| <h2 style="margin: 0;">CHANGE REQUEST</h2> | | Please see embedded help file at the bottom of this page for instructions on how to fill in this form correctly. | |
| 25.214 | CR | Current Version: | 3.0.0 |

Source: **NEC** **Date:** **1999-11-24**

Subject: **Revision of power control timing text**

Figure B-1 illustrates an example of transmitter power control timings.

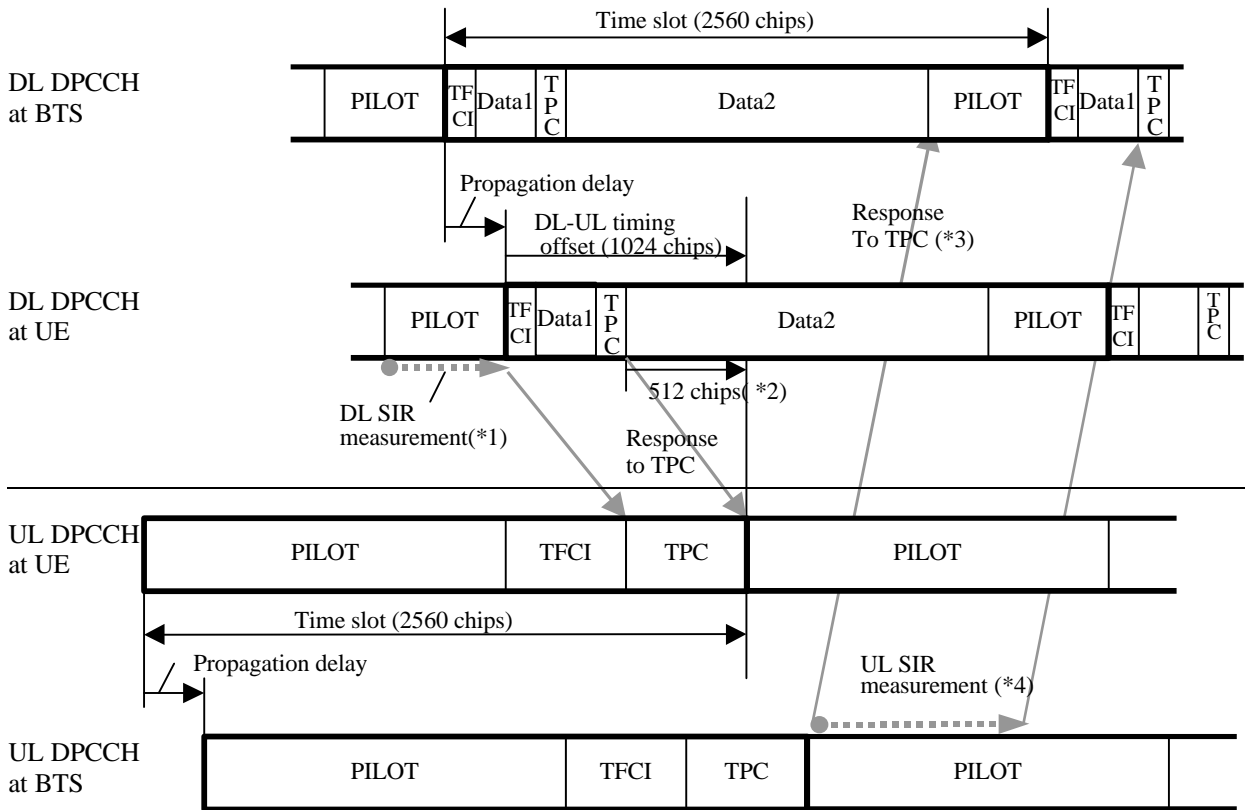
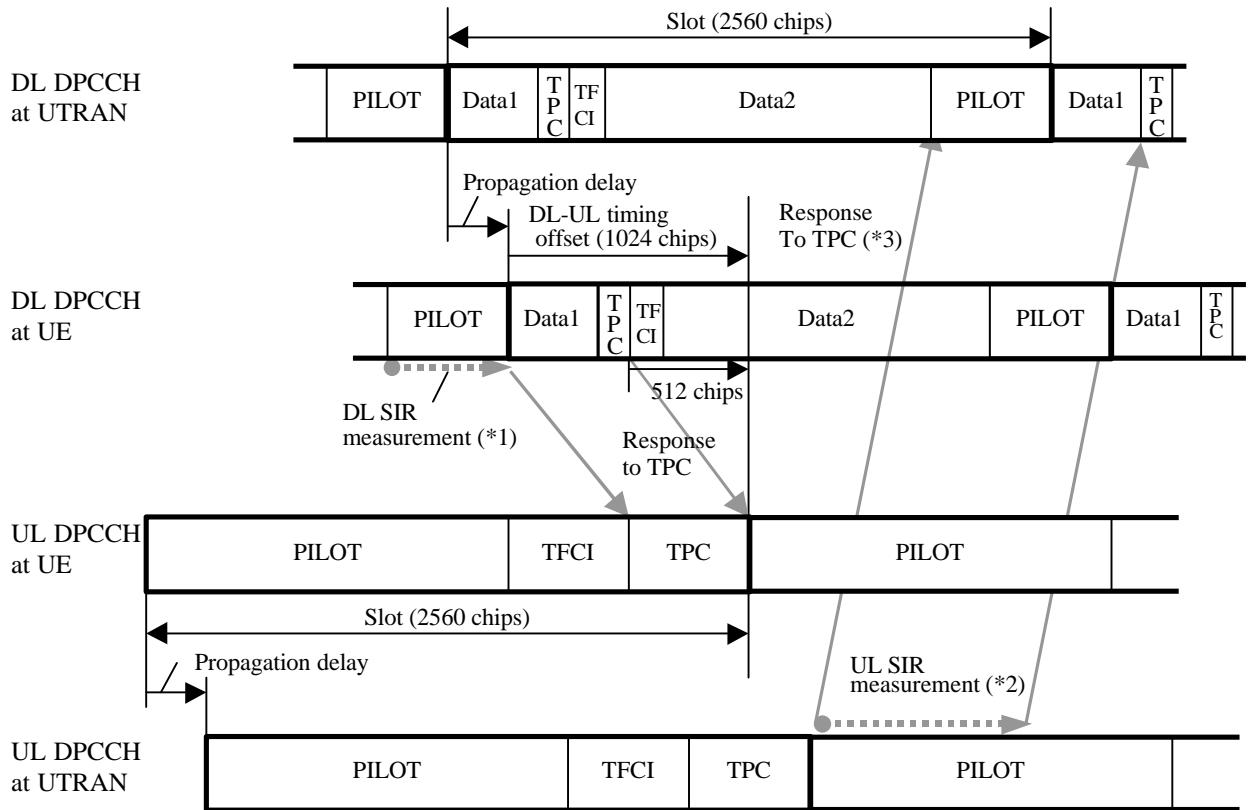
Reason for change: **According to the modifications on the downlink slot format introduced by 25.211-CR007, Figure B-1 should be updated. Terminology is also updated.**

*1,4 The SIR measurement periods illustrated here are examples. Other ways of measurement are allowed to achieve accurate SIR estimation.
 *2 Except the case of DL symbol rate=7.5ksps.
 *3 If there is not enough time for BTS to respond to the TPC, the action can be delayed until the next slot.

*1,2 The SIR measurement periods illustrated here are examples. Other ways of measurement are allowed to achieve accurate SIR estimation.

*3 If there is not enough time for UTRAN to respond to the TPC, the action can be delayed until the next slot.
